COMMUNITY BOARD FEEDBACK PACKAGE

DINING OUT NYC**COMMUNITY BOARD RECOMMENDATION FORM**

Business Name: 44 & X HELL'S KITCHEN**Cafe Address:** 622 10 AVENUE, NEW YORK, NY, 10036**Application Number:** 20240715010010**CB Review Deadline (on date or next business day):** 03-15-2025

REVISED SITE PLAN

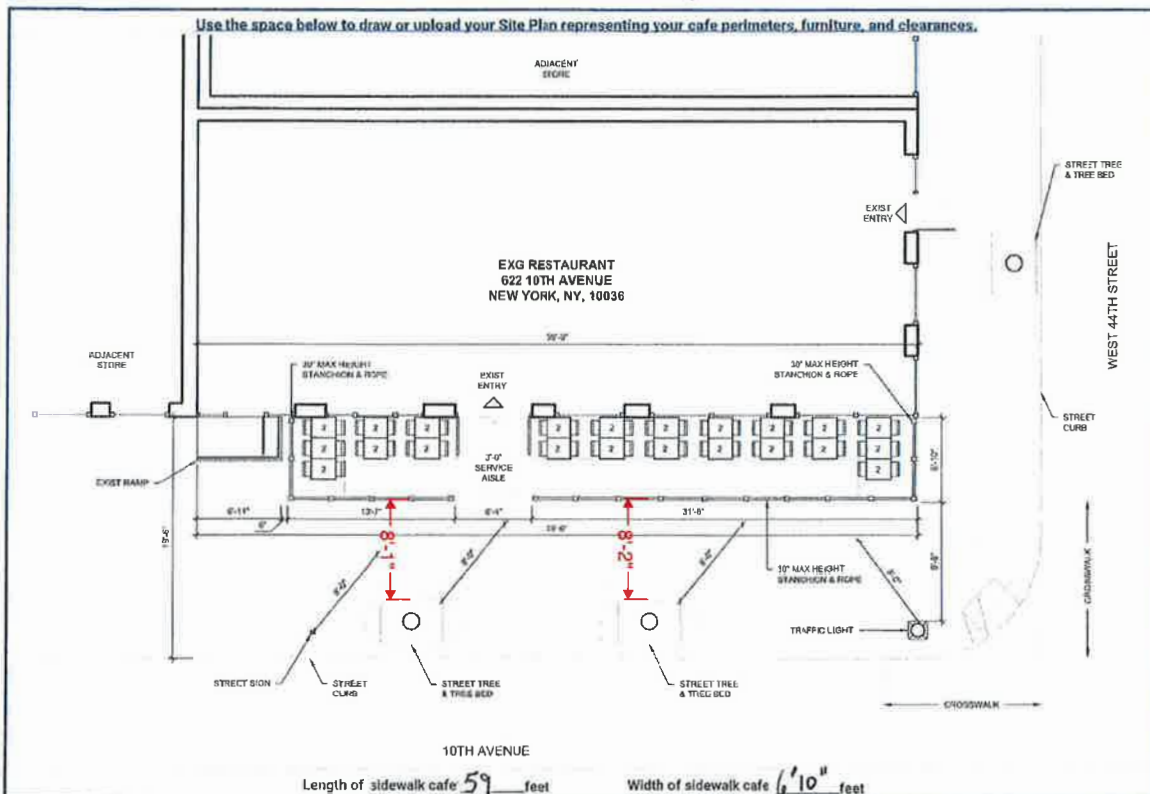
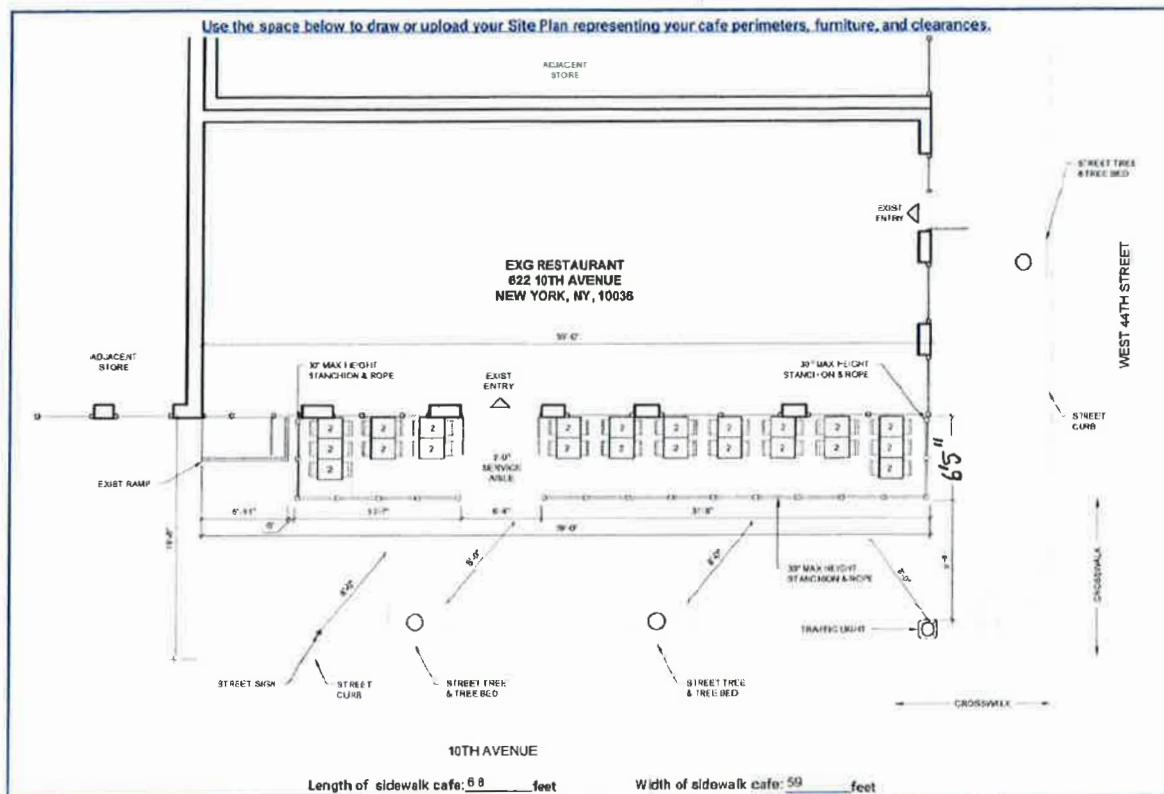
The proposed Site Plan does not provide for the required 8 foot pedestrian clear path. To provide for the required clear path, the applicant has agreed to reduce the width of the cafe to 6'5". The applicant has provided the attached Revised Site Plan.

To provide for the required 8 foot pedestrian clear path, MCB4 requests reduction of the width of the sidewalk cafe. Applicant has agreed to this modification, has reduced the width of the sidewalk cafe to 6'5", and has provided the attached Revised Site Plan.
